**MELBOURNE METRO RAIL PROJECT ENVIRONMENT EFFECTS STATEMENT**  
**INQUIRY AND ADVISORY COMMITTEE**

**MMRA TECHNICAL NOTE**

**TECHNICAL NOTE NUMBER:** 024

**SUBJECT:** Revised station cavern construction methodology

Figure 1 CD Support Class 2 (Class 1 similar less rock bolts (28 in total) and thinner shotcrete lining (150 mm))

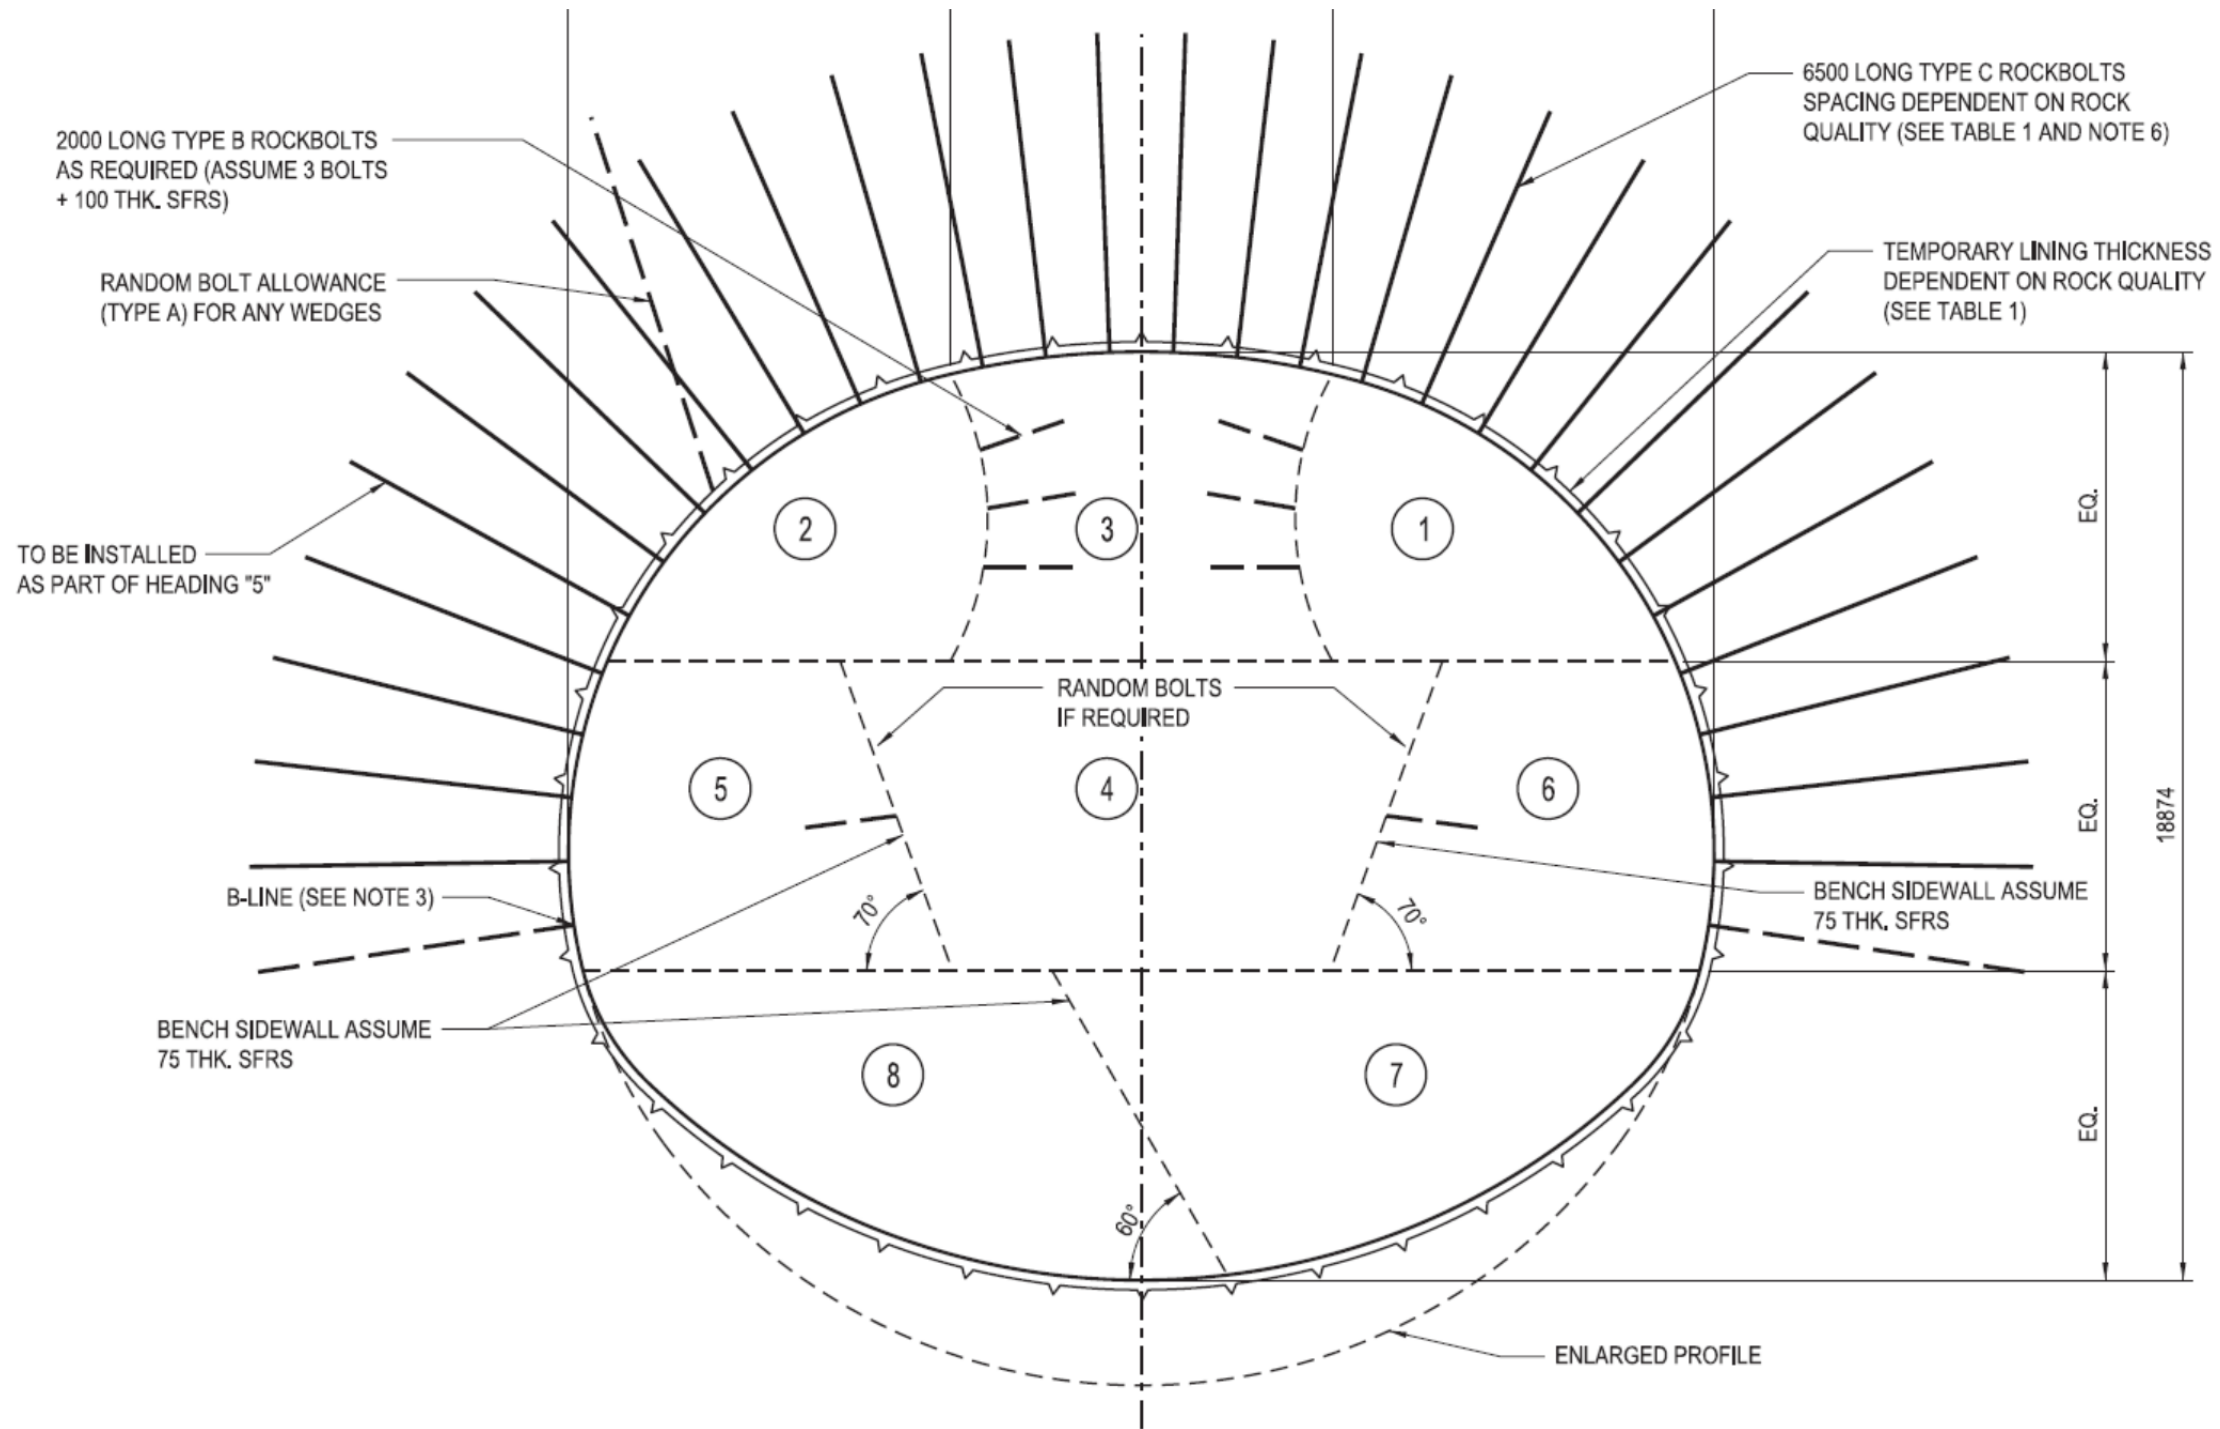
3. While not expressly discussed in the EES, the assumption for construction involved the application of one of three means of primary support for the excavation of station caverns. Support class 1 is based on using rock bolts with shotcrete. Support class 2 is similar to class 1, but involves the use of a larger number of rockbolts and a thicker shotcrete layer (Figure 1-as per attachment). Support class 3 is based on using steel reinforcement in the form of a lattice girder or steel set, and a thick layer of shotcrete (Figure 2 – as per attachment).

Figure 2 CD Support Class 3 (lattice girder shown)

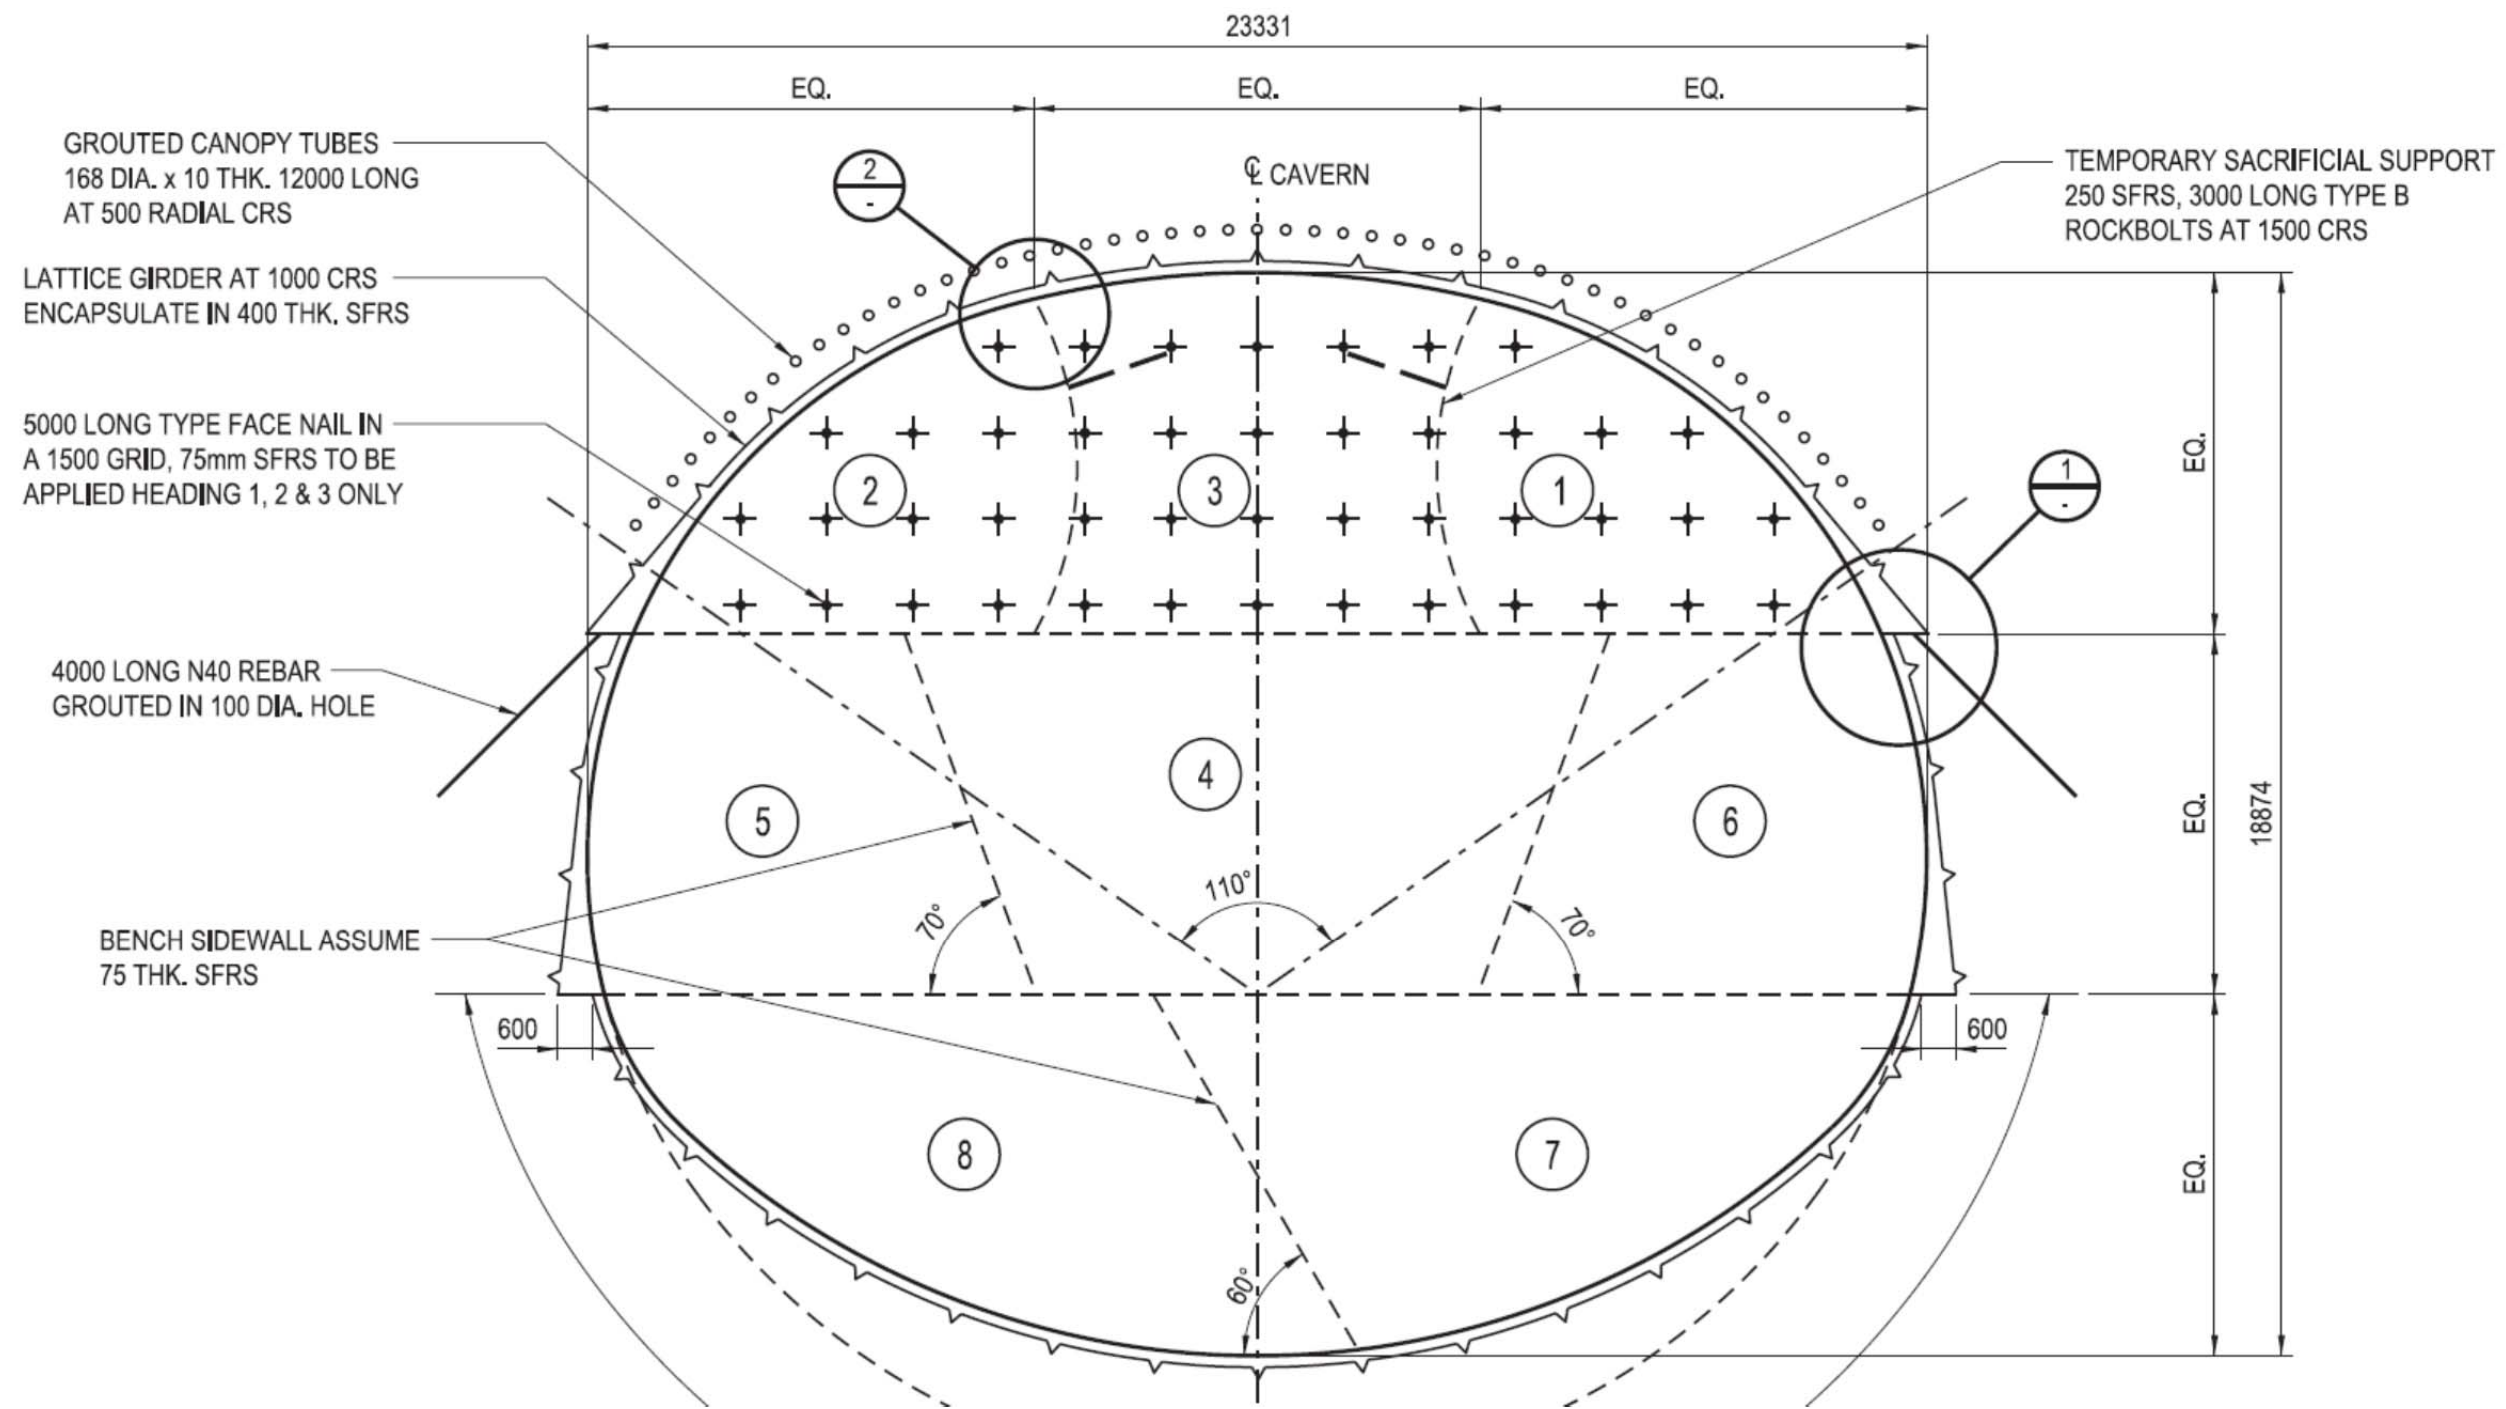
4. Based on the enhanced understanding of CBD geology based on the 260 new boreholes, support class 3 in weakest ground condition requires a Universal Steel Column size 250 UC 73 instead of a lattice girder.

5. Based on the geological profiles provided by Golder Associates prior to July 2016 and documented in EES (Melbourne Metro Rail Project - Interpreted Geological Setting EES Summary Report - Report Number. 1525532-218-R-Rev2, dated 20 April 2016), the assumed support class distributions for the CBD North and South station caverns were based on support classes 1 and 2. Support class 3 was not specified (see Tables 1 and 2 below).
6. The excavation sequences for the cavern consisted of three headings, three benches and two inverters as per Figures 1 and 2. This applies to all the three support classes and has not changed as a result of the updated geological information.
7. The revised geological profile for CBD South station indicates that Class 3 support is required for 100% of the cavern.

8. The revised geological profile for CBD North station indicates that Class 3 support is required for 100% of the cavern.
